**Partial Local Plan Review of the
Central Malta Local Plan (2006)**

**Area of Containment
at Tal-Handaq North, Qormi**

Approved

October 2021

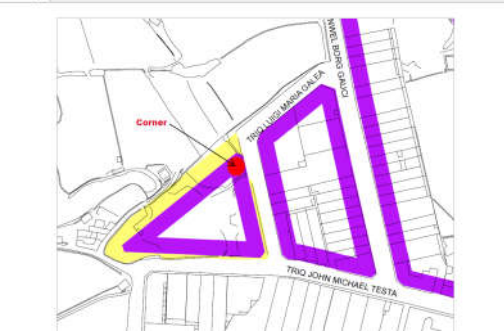
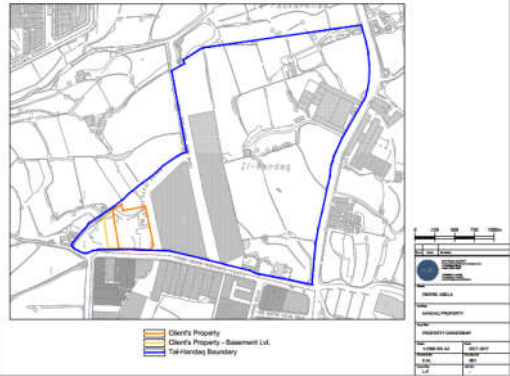
Ref	Name/Company	Date	Comments Received	Remarks
			 <p>Image A</p> <p>My clients, whilst they fully concur with the Planning Authority statement that the development layout needs to be designed “with future operational requirements in mind and so as not to repeat the current limitations</p>	<p>area. This Review also requires the provision of amenity spaces to serve as public open spaces.</p> <p>Issues relating to future dumping are operational and not in the remit of the Partial Review.</p> <p>Regarding the north road proposed by submission and the green area it is noted that these involve development outside the AoC and within ODZ fresh land which is not contemplated by the Review which is required by CMLP (2006) Policy CG05 to consider that ‘permitted development will be carried out strictly within the boundaries as designated in the relevant Planning Control Maps in Volume 3: Part B of this Plan’.</p>

Ref	Name/Company	Date	Comments Received	Remarks
			<p>experienced within the Handaq Enterprise Hub”, however they maintain that the layout being proposed in Map HA 1 on page 20 of the document issued for Public Consultation by the PA needs to be improved in order to really achieve the required goal.</p> <p>The width of main North-South road should at best be 44ft all through in order to manouver a 30ft truck from one side to an entrance on the opposite side. With a 44ft road, one would be able to have parallel parking on both side of the road adjacent to the side pavement. An appropriate turning circle is required to enter in order to achieve the PA’s aim to “cater for internalized loading and unloading, in order to ensure efficient operations”.</p> <p>We fail to understand why the PA is proposing a circa 80ft road width divided by a central strip. Up to now the norm was always to have a 44ft wide road in Industrial Estates.</p> <p>Although we understand the PA’s intention to introduce the central strip in order to enhance the industrial area with some landscaping and open space, however the central strip in the middle of the road is definitely not the solution as this will hinder the</p>	<p>Other proposals have been taken on board and incorporated in the revised scheme for the AoC.</p>

Ref	Name/Company	Date	Comments Received	Remarks
			<p>maneuvering of trucks in that area, since the required turning circle cannot be achieved, thus causing a traffic problem</p> <p>Apart from obstructing maneuvering from experience it will finish off as dumping strip as unfortunately no entity will take care of this landscaping strip. As described further down, there is a better alternative how to achieve a true landscaping enhancement in this area, rather than introducing a narrow landscaped central strip.</p> <p>The PA's proposed road layout can be improved in order to facilitate traffic flow as well as taking into consideration the owners' parcels to lessen the loss of land for road construction.</p> <p>The layout in Image B proposed by my clients provides an alternative which basically creates 2 traffic loops which facilitates much better traffic flow.</p>

Ref	Name/Company	Date	Comments Received	Remarks
			 <p data-bbox="846 1029 943 1054">Image B</p> <p data-bbox="846 1082 1518 1374">This alternative layout proposes also to open up the north road from west to east in order to facilitate the flow even to the other side of the development area. It does so by pushing the building alignment slightly inwards to create a herring bone parking lot, a facility that will enhance the attractiveness of the commercial area.</p>

Ref	Name/Company	Date	Comments Received	Remarks
			<p>Do not hesitate to contact us if you require any further clarifications.</p> 	
HN2 006	Perit Daniel Micallef	26/10/2017	<p>The undersigned is submitting this objection to the Partial Local Plan Review of the Central Malta Local Plan on behalf of Mr. Ralph Attard, owner of the plot shown marked hereunder in red.</p> 	<p>Objection noted and has been taken on board in the revised scheme.</p>

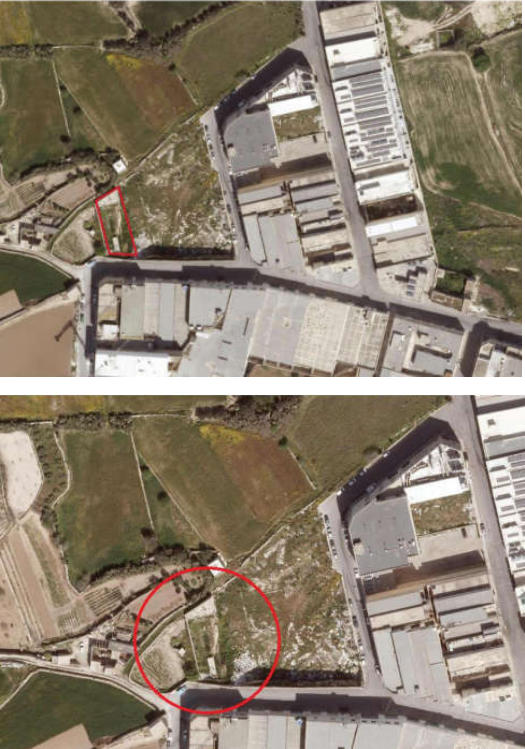
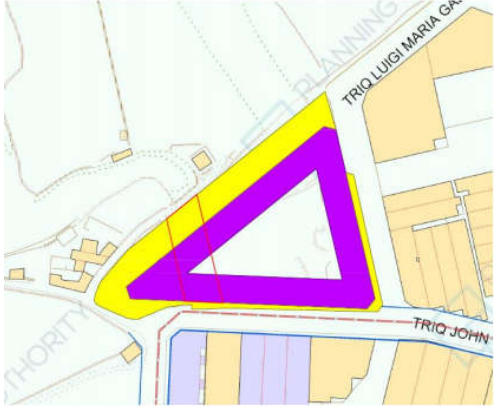
Ref	Name/Company	Date	Comments Received	Remarks
			<p>The Policy Paper: Way Forward - Areas of Containment (2012) was issued with the aim to guide development proposals within AoC's within the short term until these areas are fully planned comprehensively. According to this policy paper (Appendix 1 - Table 5.2), the planning parameters of this AoC are to be established through a Planning Control Application Process, which as stated by the Local Plans Unit has not been determined yet (mins. 46 - 49). In this case, the site in question has already been granted permission for the construction of warehouses (PB2329/91, PA134/94 and PA797/95 - doc. 1A in file PA776/98), but the approved works could not be completed following a series of events as documented by the architect in docs. 50 - 50A (severe weather conditions & court case).</p> <p>Consequently, the current application (PA7175/07) seeks development permission for the construction of a warehouse within the site in question (drwg. 84A).</p> <p>However, in terms of the Policy Paper: Way Forward - Areas of Containment, in particular paras. 4.6.1 (vertical extensions to existing operations), 4.6.2 horizontal</p>

Ref	Name/Company	Date	Comments Received	Remarks
			<p>extensions to existing operations), 4.7 (infill sites) and 4.8 recommendations for AoCs subject to PC application & Structure Plan Review), the site in question does not yet qualify for development. In this regard, the development of this site could compromise the planning parameters which are to be established for this particular AoC.</p> <p>The above is to be treated as a preamble and justification why the permit was never executed in its entirety, and why construction could not proceed as originally planned as per permits PA 2329/91, renewed by PA 134/94.</p> <p>The Document through MAP HA1 is proposing the formation of a new road right through the property of Mr. Attard as marked in yellow (extract hereunder), reducing the plot AT LEAST by 25%.</p>

Ref	Name/Company	Date	Comments Received	Remarks
			 <p data-bbox="846 730 1518 976">The existing road configuration is as approved in the permits quoted, and the formation of the new proposed road will not be addressing or improving much the vehicle circulation since the existing roads provide adequate vehicular circulation.</p>

Ref	Name/Company	Date	Comments Received	Remarks
			 <p data-bbox="846 730 1518 1182">Alternative routes already exist, and the proposed road will only mean more road surface area which is not needed and an injustice for Mr. Attard given the parameters when the plot was bought were very clear and its only due to situations on which he had no control that the development was not executed. If this was not the case, the road as being proposed would not have been possible, since not just the reservoirs would have been completed but the whole development as approved.</p> <p data-bbox="846 1203 1518 1337">The site is already bound by a footpath at the back, as shown also in the approved plan above, and if any form of access or for aesthetical purposes, a footpath needs to be</p>

Detail of Map HA2 of this policy

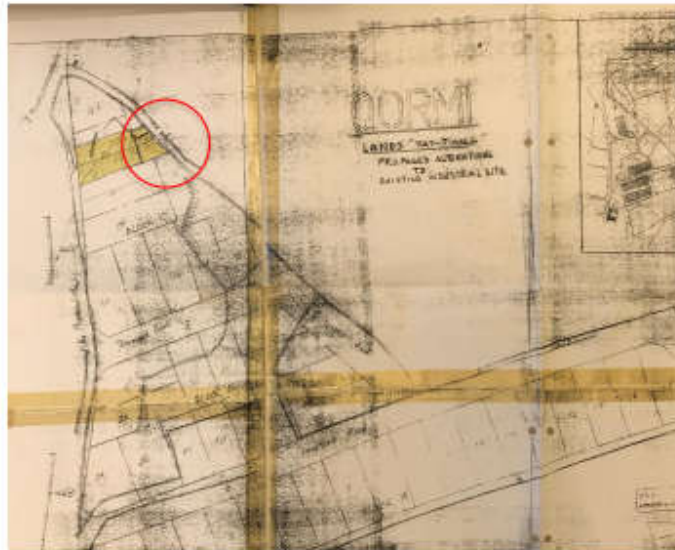
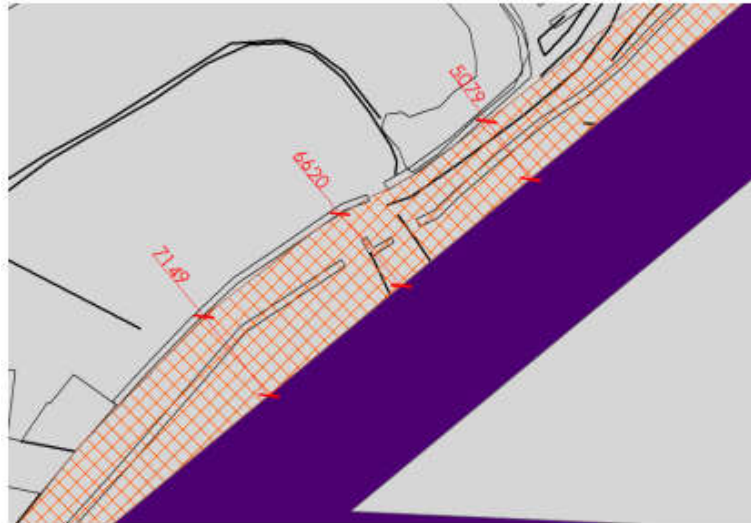
We express our satisfaction that the schemed road previously proposed to extend behind my client's property has been removed from the published policy map. Our submission relates to the proposed pedestrian access at the back of my clients property, to which we had already referred in our previous submissions. In principle, we agree to this, even due to the fact that this already exists on site. In fact, it is also visible in the original permit PA/2329/91 – extract of which is being presented hereunder.

alignment is on the AoC boundary, that is on the rubble wall along the existing passageway being 3m offset perpendicular from existing structure as indicated in figure detail of Map HA2 below. In order to ensure adequate urban design and to facilitate the setting out of the alignment, a straight building alignment was considered more appropriate rather than the existing irregular alignment of the existing passageway.

Our objection relates to the size of the pedestrian access as proposed, given also an existing passage is already on site. Our interpretation of the published plans is being presented hereunder, where the path along Mr. Attard's property as proposed is 5.08m from the East side and 6.6m from the West side.

height of 15.4m is already higher than the 10.5m height previously followed for the AoCs. The limit of the number of floors and/or floorspace is included to control development density particularly with respect to transport considerations emanating from the Traffic Impact Assessment carried out for this Partial Local Plan Review. Whilst conventional development is considered throughout Zone A due to fragmented land parcels, Zone B is proposed to be subject to comprehensive development with a set limit of gross floorspace.
